HISTORIC AND DESIGN REVIEW COMMISSION

HDRC CASE NO: 2018-167
ADDRESS: 518 E LOCUST
LEGAL DESCRIPTION: NCB 1741 BLK 11 LOT 5
ZONING: MF-33, H
CITY COUNCIL DIST.: 1
DISTRICT: Tobin Hill Historic District
APPLICANT: Darren Craddock
OWNER: Darren Craddock
TYPE OF WORK: Installation of powder-coated aluminum front yard fence (to mimic wrought iron)
APPLICATION RECEIVED: March 29, 2018
60-DAY REVIEW: May 28, 2018
REQUEST:

The applicant is requesting a Certificate of Appropriateness for approval to install aluminum powder coated front yard fence to mimic wrought iron, with a driveway gate.

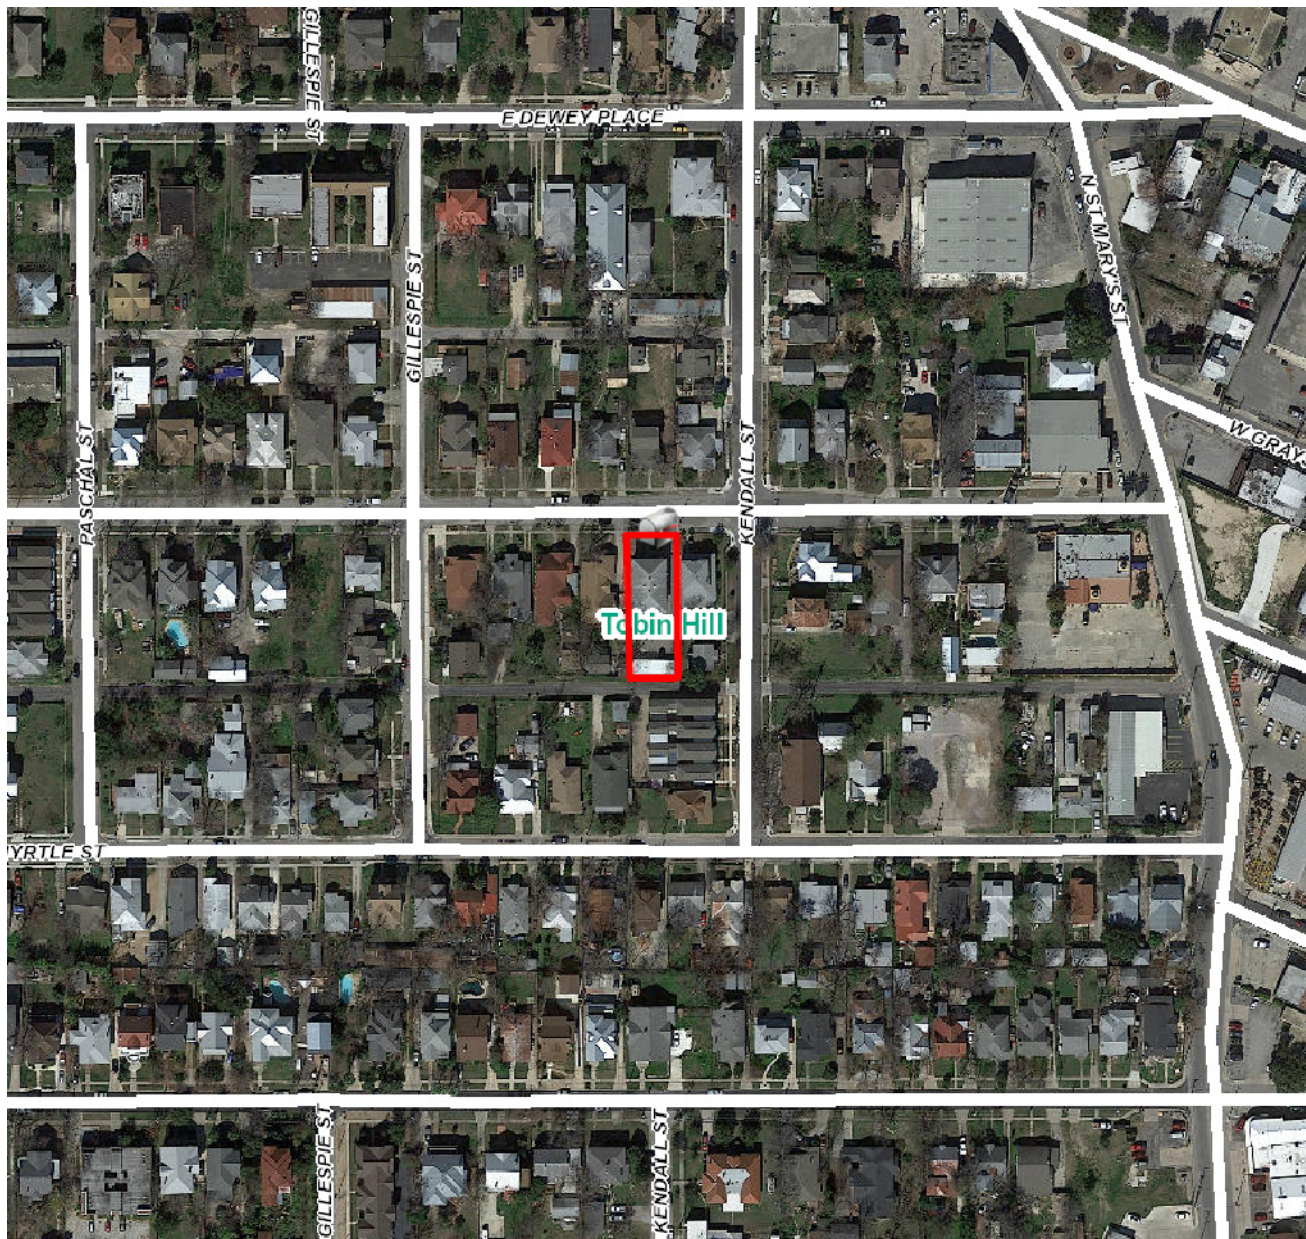
- b. FENCE LOCATION - The applicant has proposed to install a wood picket fence to span the width of the property, including a gate spanning across the driveway. According to the Guidelines for Site Elements 2.B.ii, new front yard fences should not be introduced within historic districts that did not historically have them. While staff finds that a fence was not currently present on this property, fences are found on E Locust and within the Tobin Hill Historic District. Additionally, per the Guidelines for Site Elements 2.C.i., privacy fences, including the proposed driveway gate, should be set back from the front façade to reduce their visual prominence. Staff finds that the fence should turn at the driveway to meet the corner of the structure, rather spanning across the driveway as proposed. Staff finds that the driveway gate, if included, should be set back behind the front façade plane of the structure.

- c. FENCE DESIGN - According to the Guidelines for Site Elements 2.B.i., the design of the fence should respond to the design and materials of the primary historic structure or structures of a similar style in the neighborhood in relation to scale, transparency, and character. Staff finds that the proposed powder-coated wrought iron fence is appropriate for this structure and on this block.

Staff recommends approval based on finding b and c with the following stipulations:

- i. The fence should turn to meet at the corner of the structure as opposed to spanning across the driveway.
- ii. The driveway gate should be located behind the front façade plane of the structure or removed from the design.
- iii. That no portion of the fence exceed four feet in height.
